RIVERFRONT PLACE
PHASE IV - OFFICE BUILDING
W.C. BRADLEY CO.
COLUMBUS, GEORGIA

ENLARGED PLAN - OFFICE LOBBY - LEVEL 3.7

COMMISSION NO: 20-084
DRAWING NO: AO1-03

PRINTED	
Date	Issue/Revision
8/16/21	FOUNDATION PERMIT
10/19/21	PERMIT SET
11/18/2021	FOUNDATION REVISION
12/17/2021	IFC
02/28/2022	BULLETIN #3

1 FLOOR PLAN - LEVEL 3.7 - OFFICE LOBBY
3/32" = 1'-0"

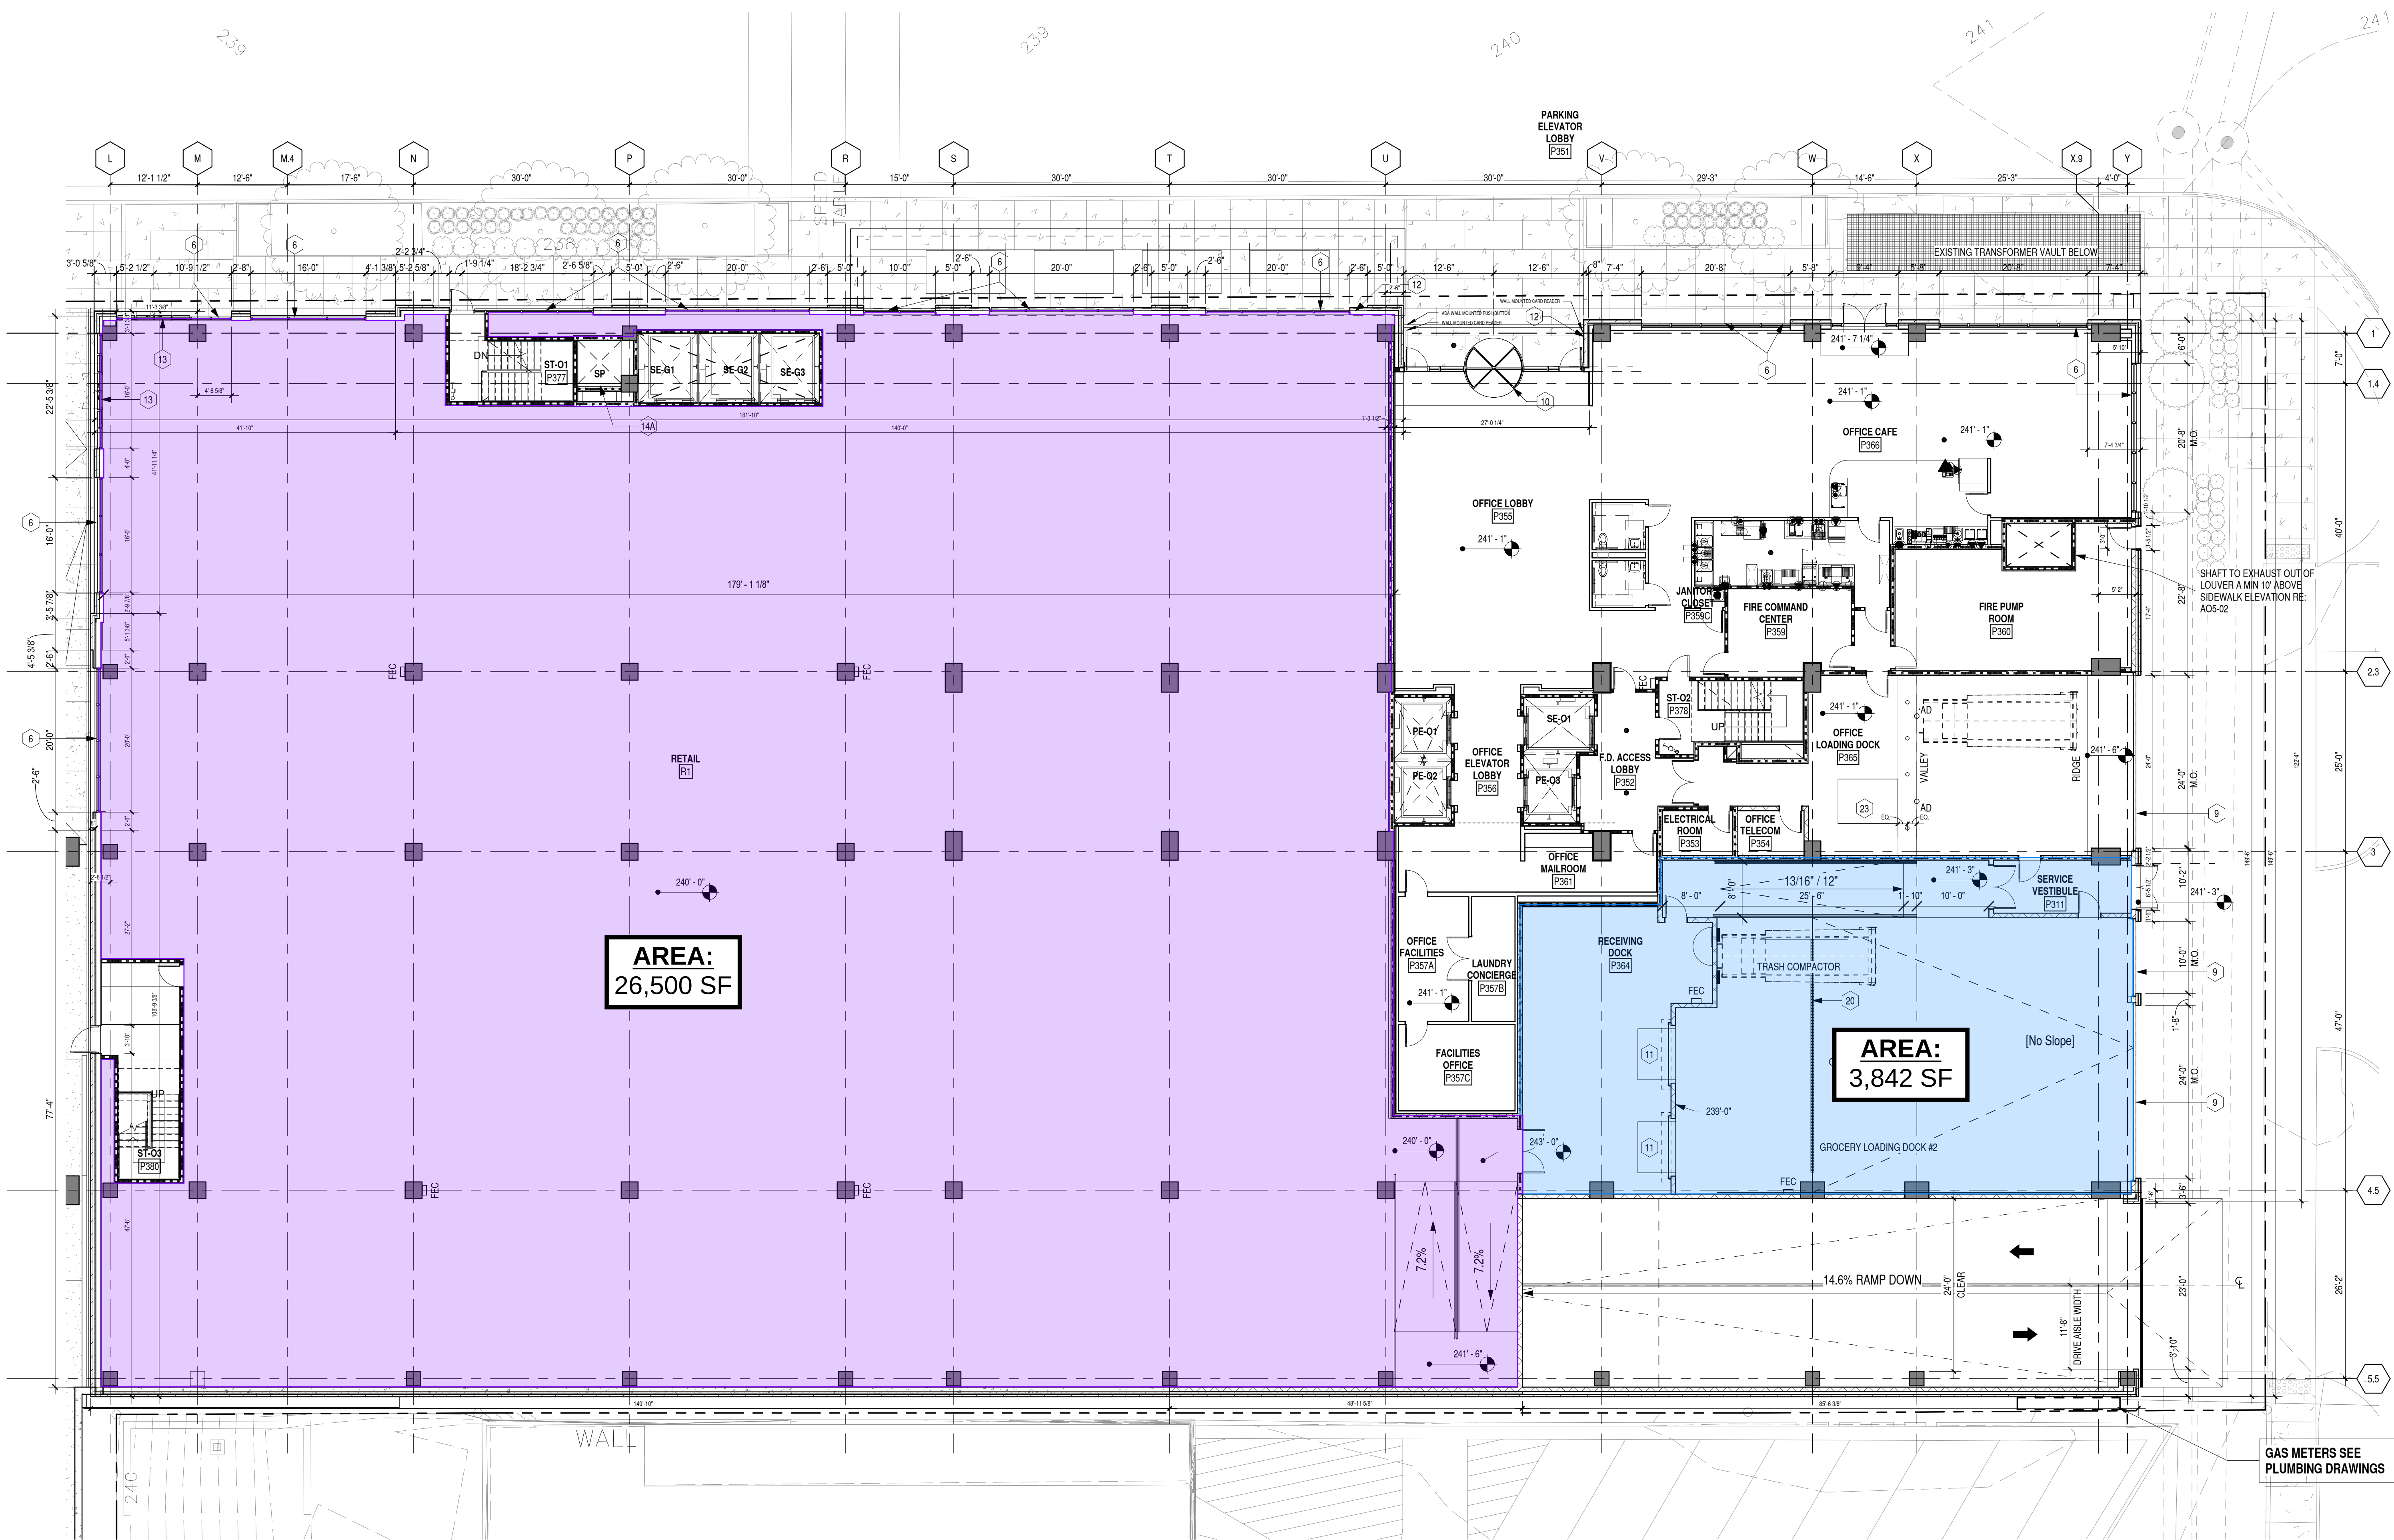
NOTE: REVISED AREA DRAIN
LOCATIONS ON PARKING DECK
